Service Information

Model 580, 581, 582
Serial No. _____
Subject Addition of Belt Stopper
to Capstan Motor Ass'y.

No. NR-0038
Date 2/16/82

Fig. 1

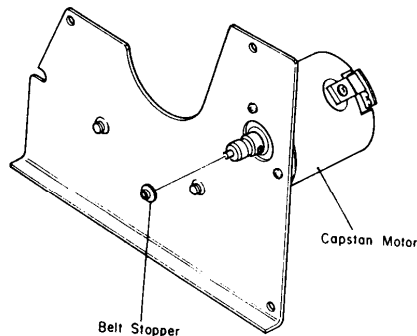
In order to prevent the possible coming off of the Capstan Belt from the Capstan Motor Pulley, it is recommended to install the Belt Stopper in the early production of the model 580, 581 and 582.

- 2-1 Remove the Top Cover Ass'y.
- 2-2 Clean the Capstan Motor Pulley.
- 2-3 Press the Belt Stopper into the Capstan Motor Shaft.
Refer to Fig. 1 and Fig 2.
 - *Do not exert excessive force.
 - *Do not make a gap between the Capstan Motor Pulley and the Belt Stopper.
- 2-4 Put the Capstan Belt back.
- 2-5 Check "Wow and Flutter" and "Speed."
- 2-6 Assemble the Top Cover Ass'y.
